**Randwick City
Council**

DA COMPLIANCE REPORTS

**ORDINARY COUNCIL MEETING
TUESDAY 25 NOVEMBER 2014**

Folder /DA No:	DA/560/2014
PROPERTY:	89-89A Mooramie Avenue, KENSINGTON NSW 2033
Proposal:	Change of use of the existing dwelling house and out building to a boarding house including associated alterations and additions to the building and a new disabled ramp
Recommendation:	Refusal

Figure 1: Extract of site plan showing tree removal (source: New Era Design)

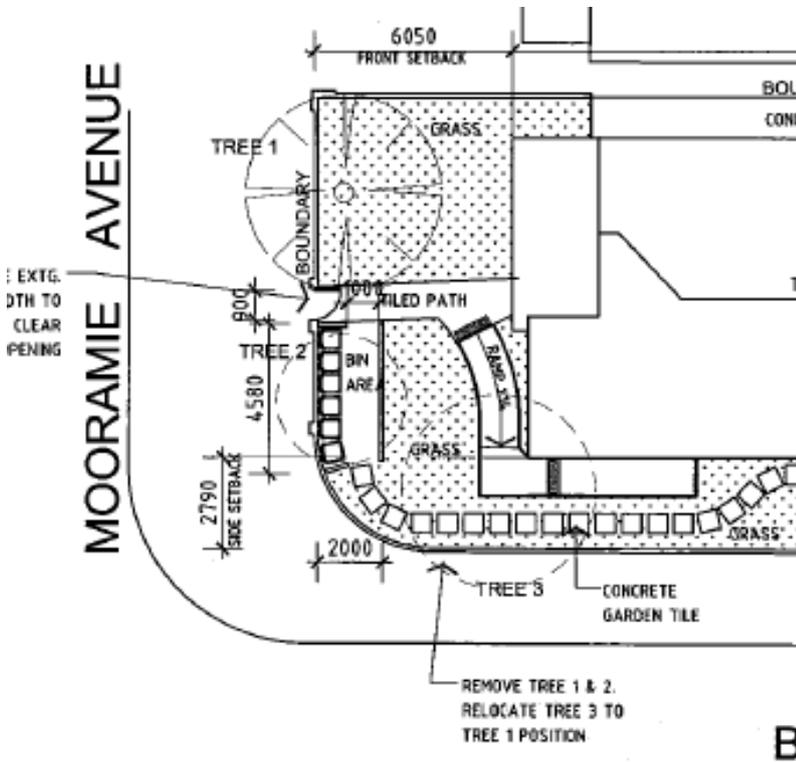
The site contains three (3) established trees within the front setback of the property, varying in height from 5 metres to 6 metres. As shown in Figure 1 below, the proposal seeks to

remove Trees 1 and 2, located closest to the front boundary and transplant Tree 3 in the position of Tree 1.

The applicant indicates the removal of two (2) trees is necessary to facilitate the development. In particular, Tree 2 is required to be removed to accommodate the new waste storage area and Tree 3 to allow a realignment of the entry path and establish a primary point of entry from the southern side of the dwelling.

The application was not supported by an arborist report specifying the trees species, aesthetic significant or safe useful life expectancy. In the absence of this information a full assessment of impact cannot be made.

- The proposed relocation of the primary entry to the site to the side of the dwelling is unnecessary and contrary to modern urban design and crime prevention principles;
- The necessity to provide a waste management store within the front setback, resulting in the loss of soft landscaping and trees is symptomatic of an overdevelopment of the site and poor functionality;
- There is insufficient information to support the proposed transplanting of Tree 3;
- There is no reasonable grounds to support the removal of Tree based on the information currently provided.

- No attempts have been made to elevate the amenity of the site through redistribution of soft landscaping or compensatory plantings; and
- The proposed works are considered to contribute to a diminished aesthetic outcome.
